Parramatta Leagues Club Hotel

Transport, Parking and Accessibility Assessment Response to Submissions

7 December 2021

The Transport Planning Partnership

Figure 2.2: Proposed Typical Vehicle Access Arrangements – Non Event Mode

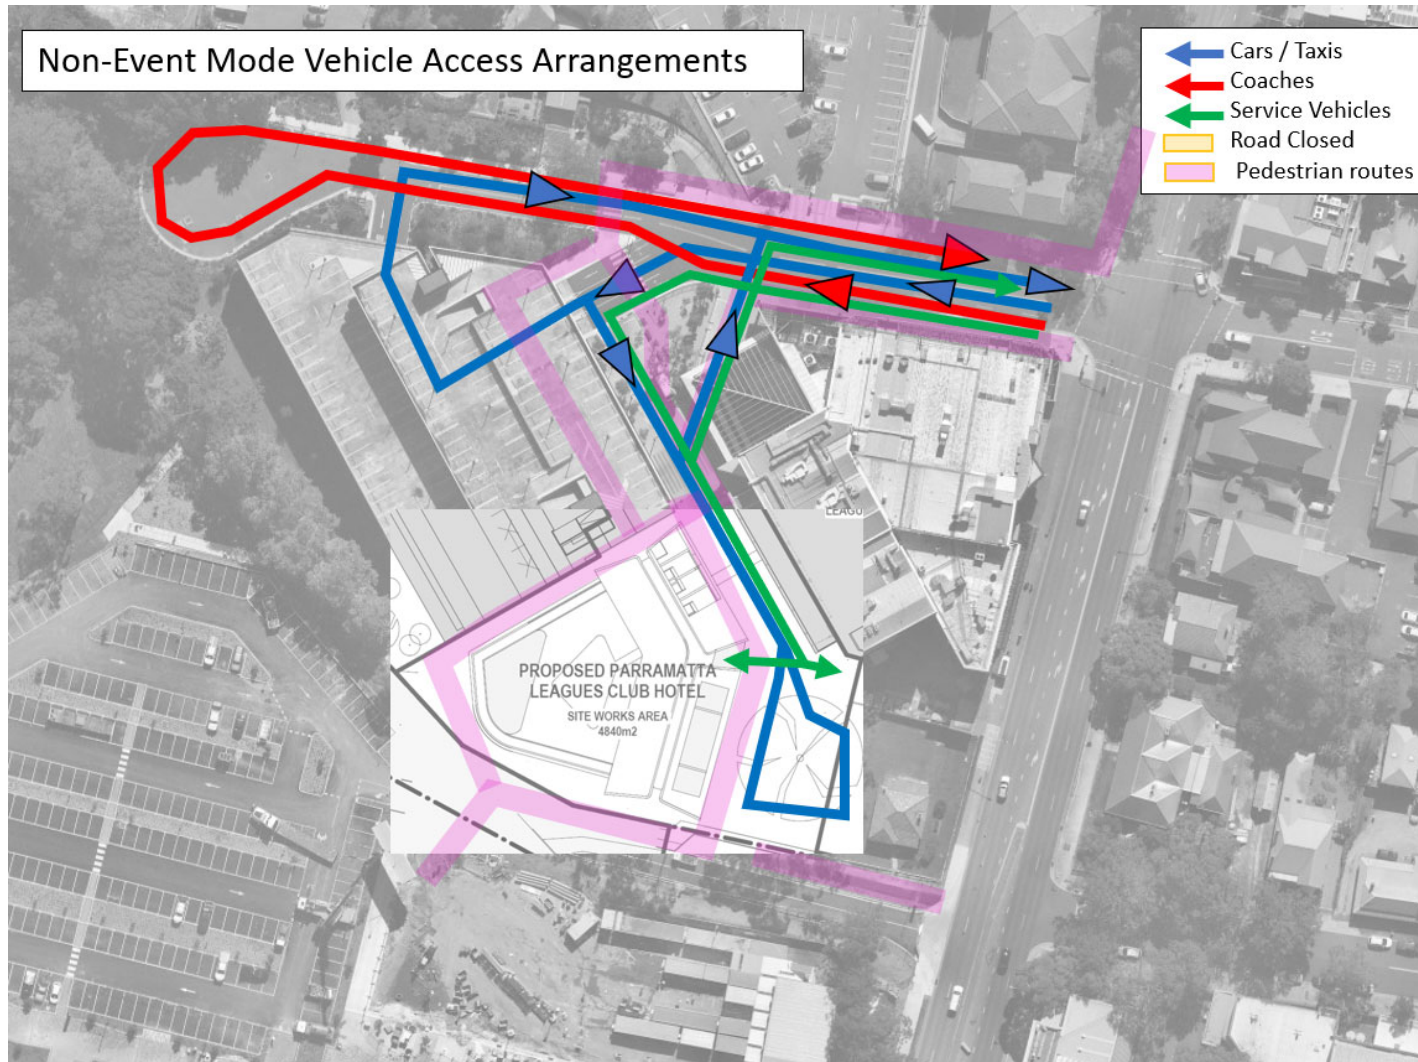
The proposed vehicle access arrangements for the modified Hotel development during non-event and event modes at the Stadium are summarised in Figure 2.2 and Figure 2.3.

As such the proposed vehicle access arrangements for the Hotel have been modified such that all vehicle access is to be provided to and from the proposed Hotel's porte cochere, loading dock and car parking via Eels Place.

Figure 2.13: Proposed Pedestrian Access Arrangements

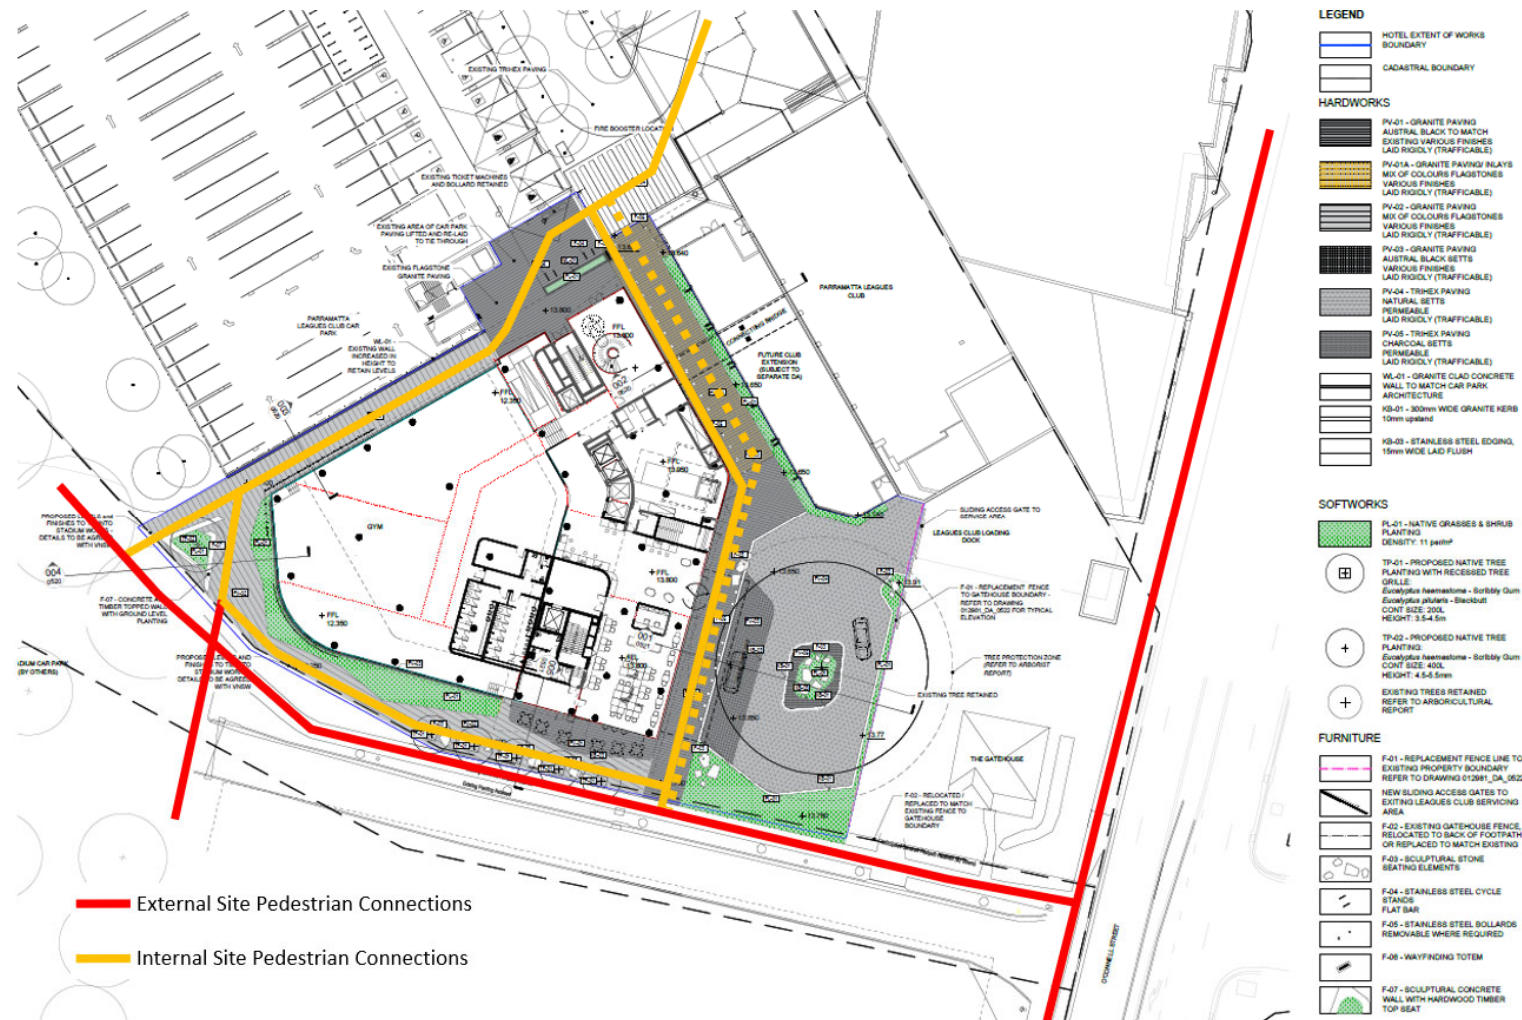
The creation of a pedestrian priority “shared” connection along Eels Walk will be enhanced through a reduced trafficable pavement width for vehicles and the provision of a separate adjacent walkway protected with bollard treatments.

The proposed arrangements for Eels Walk are shown in Figure 2.13.

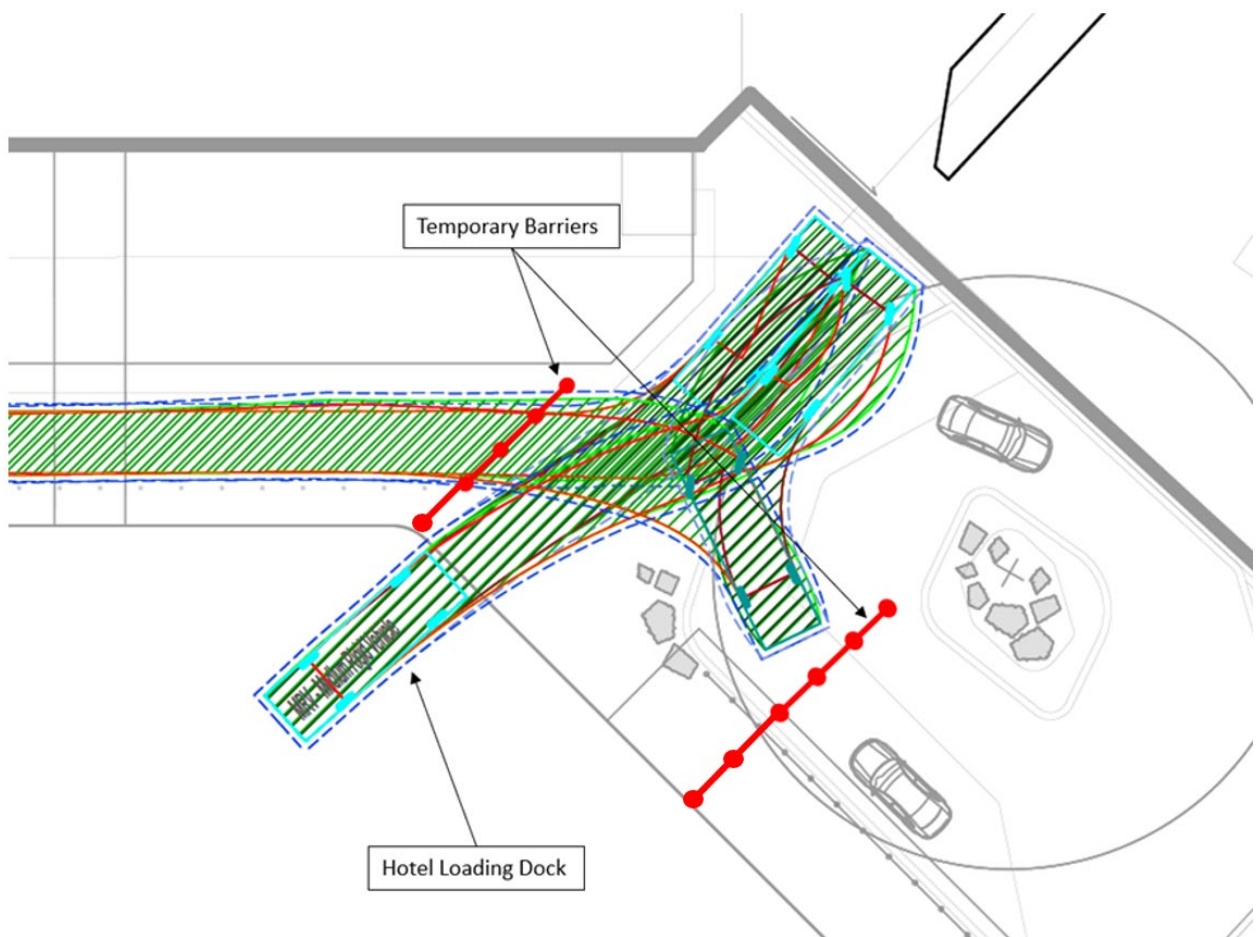
Access for the MRV to the on-site loading dock will require a reverse manoeuvre from the internal circulation road into the dock.

The reverse movement would cross one of the potential pedestrian routes between the Hotel lobby and the Club.

To address this potential conflict it is recommended that:
